Addendum No. 6

Invitation for Bids ("IFB") No. DCAM-22-CS-IFB-0003

Construction Services for the Renovation of Dally Building Swing to OJS

Questions & Answers Spreadsheet

ELECTRIC 6th Floor Elec Room South Survey Notes

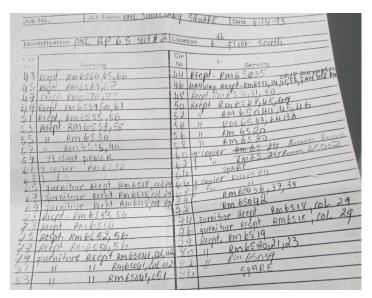
| 35. | 6 th Floor Power Riser PNL RP6S and RP6N need location and panel schedule. Also, Panel RP-1CSC Panel schedule and location. Please, provide. The folder "IFP – Permit B2200261 drawings" appears to have drawings with similar file names with the exception of "_Rev 1 and _Rev 11" the end of the file names. Can you please let us know which files are applicable for this project. | Panels RP6S and RP6N are existing and located via keyed sheet notes on the floor plans E6.2A and E6.2B. Panel schedules for RP6S and RP6N are attached in this response. Panel RP-1CSC is located on sheet E2.C1.B via keyed note. Panel RP-1CSC is located on Sheet E7.3. 1. A-Series – use all drawings uploaded by Gilberto Gomez on March 28th (67 drawings) 2. G-Series – use all _Rev 1 drawings uploaded by Gilberto Gomez on March 28th (3 drawings) 3. C-Series – use all drawings uploaded by Gilberto Gomez on March 28th (6 drawings) 4. FP-Series – use all drawings uploaded by Gilberto Gomez on March 28th (7 drawings) 5. P-Series – use all drawings uploaded by Gilberto Gomez on March 28th (6 drawings) 6. M-Series – use all drawings uploaded by Gilberto Gomez on March 28th (40 drawings) 7. E-Series – use all drawings uploaded by Gilberto Gomez on March 28th (65 drawings) 8. TA-Series – use all drawings uploaded by Gilberto Gomez on March 28th (15 drawings) |

Panel RP6S Sec 4: Siemens P1, 208Y/120V, 3PH, 4W, 250A Max MLO, Date 8/7/2018

Panel RP6S Sec 1: Siemens CDP-7, 208Y/120V, 3PH, 4W,

Panel RP6S Sec 2: Siemens CDP-7, 208Y/120V, 3PH, 4W,
